# Access Compliance Report

## Public Rights-of-Way

### (Curb Ramps)

Intersection ID: 10034711	Main Street: POINDEXTER_DR	Cross Street: N/A	Location: S
ADA ID: FDE4FD4BC7FF	Ramp Type: Perp	Initial Pass/Fail: Fail	Overall Compliance: No
		Severity Score: 25

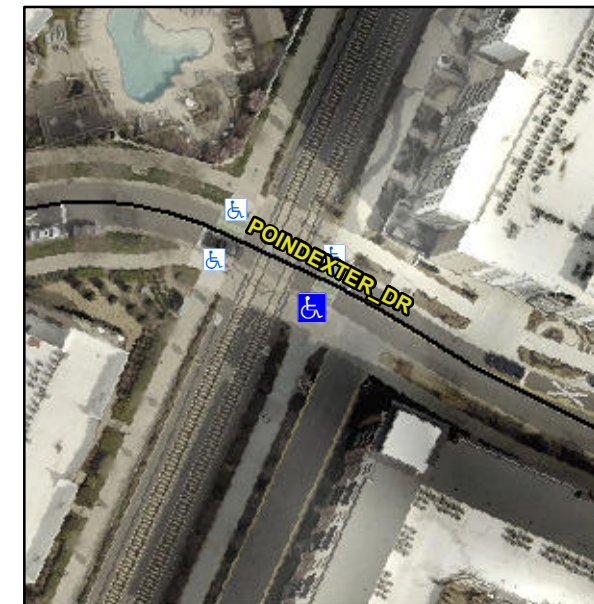
**Not Found, R304.5.3**

Compliance	Description	Data	Compliance	Description	Data
N/A	Ramp Length (in)	93.0	Yes	Ramp Slope (%)	5.6
Yes	Ramp Width (in)	137.0	No	Ramp XSlope (%)	7.3
N/A	Flare Type LT	N/A	N/A	Flare Type RT	N/A
N/A	Flare Slope LT (%)	N/A	N/A	Flare Slope RT (%)	N/A
N/A	Flare Traversable LT?	N/A	N/A	Flare Traversable RT?	N/A
N/A	Landing Length (in)	N/A	N/A	DWS Provided?	N/A
N/A	Landing Width (in)	N/A	N/A	DWS Contrast?	N/A
N/A	Landing Slope (%)	N/A	N/A	DWS Length (in)	N/A
N/A	Landing X Slope (%)	N/A	N/A	DWS Full Width?	N/A
N/A	Landing Curb? (Y/N)	N/A	N/A	DWS Offset (in)	N/A
N/A	Shared Landing?	N/A			
N/A	Gutter Ponding?	N/A	N/A	Gutter Slope (%)	N/A
N/A	Gutter Lip Ht (in)	N/A	N/A	Gutter X Slope (%)	N/A
N/A	Painted X Walk1?	Yes	N/A	Painted X Walk2?	N/A
	X Walk 1 Direction	To NE		X Walk 2 Direction	N/A
N/A	X Walk 1 Width (in)	136.0	N/A	X Walk 2 Width (in)	N/A
	X Walk 1 Slope (%)	1.4		X Walk 2 Slope (%)	N/A
	X Walk 1 X Slope (%)	2.4		X Walk 2 X Slope (%)	N/A

N/A	Ramp inside XWalk1?	Yes	N/A	Ramp inside XWalk2?	N/A
	Road Slope (%)	N/A	N/A	Clear Space?	N/A
	Road X Slope (%)	N/A	N/A	Clear Space to XWalk (in)	N/A
N/A	Any Obstructions?	N/A	N/A	Storm Grate/Utility Hazard?	N/A
	Obstruction Type			Storm Grate/Utility Type	
		N/A			N/A
			Yes	Surface Condition? (G/P)	Good

**Remove & Replace Entire Ramp.**
